Amendments To The Drawings:

REMARKS/ARGUMENTS

Annotated Sheet Showing Changes of FIGS. 1-2

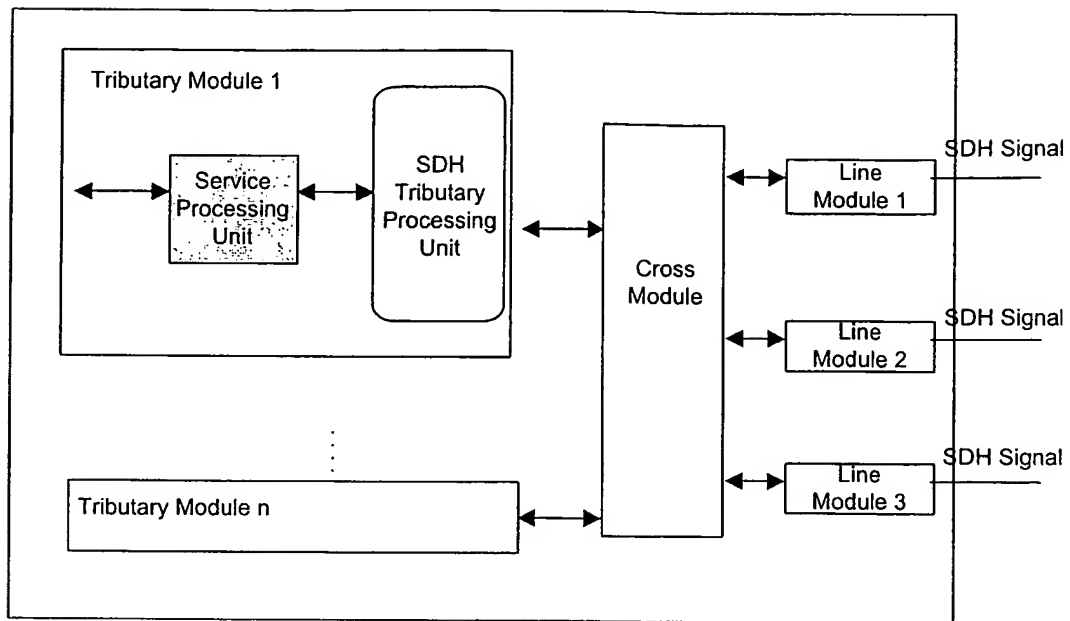
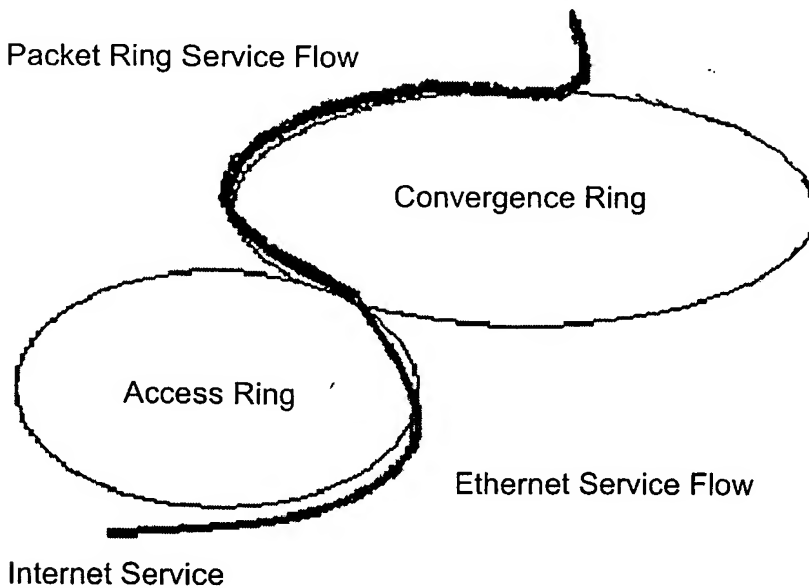
In the office action (page 2), the drawings stand under 37 CFR 1.121(d) as they should be designated by a legend such as --Prior Art--.

In response the Applicant has subsequently amended FIGs. 1-2 to include the legend --Prior Art-- to remove the basis for this objection. Therefore, the examiner is respectfully requested to withdraw this objection to the drawings.

(PRIOR ART)

(PRIOR ART)
